NABCO ENTRANCES TECHNICAL BULLETIN

Reconfiguring Rocker Switch on Swing Doors with U Series Control

Bulletin Number: **37**

PART # 22-11350 - REVISED SWITCH TEXT AND WIRING

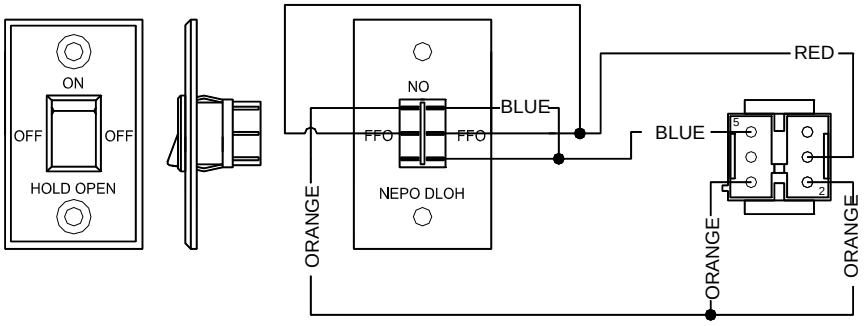
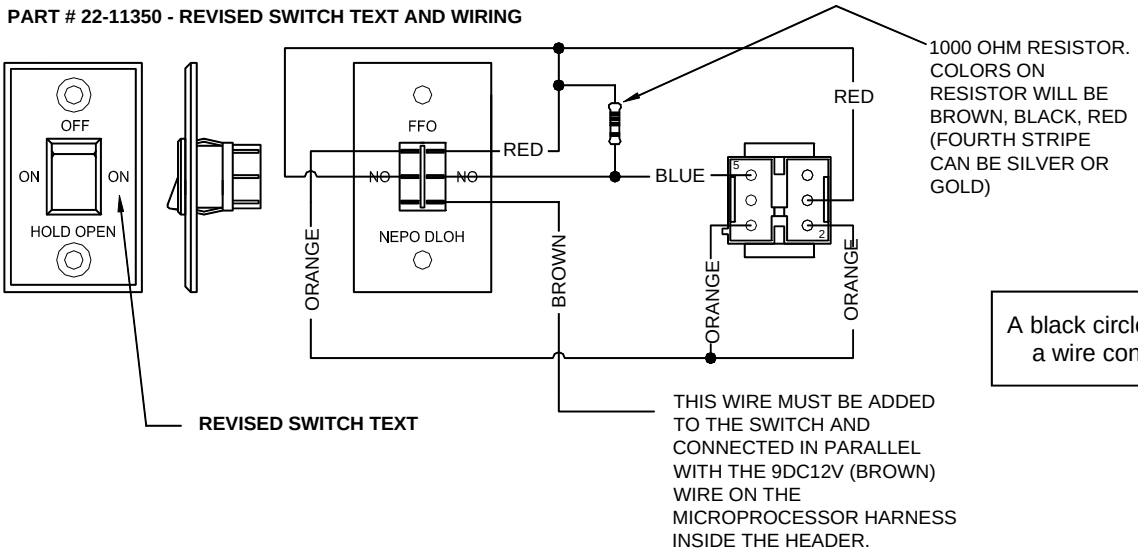
Issue: On current rocker switch configurations, if the rocker switch (P/N 12-9551) is set to HOLD OPEN while the door is open, the door will first fully close before going to HOLD OPEN.

Reason: The rocker switch must first pass through the OFF position before switching to HOLD OPEN. This momentarily turns off the control thereby causing the door to first close.

Solution: To eliminate this, re-wire the rocker switch as shown below. The wording on rocker switch face plate will also need to be changed as shown below. Note: a new wire must be connected *in parallel* with the 9DC12V BROWN on the control's main harness (refer to tagged wires on control harness). This wire is routed to a pin on the rocker switch as shown. A 1000 ohm 1/4 watt resistor is also added as shown in the diagram. We will be making this change to current production models soon.
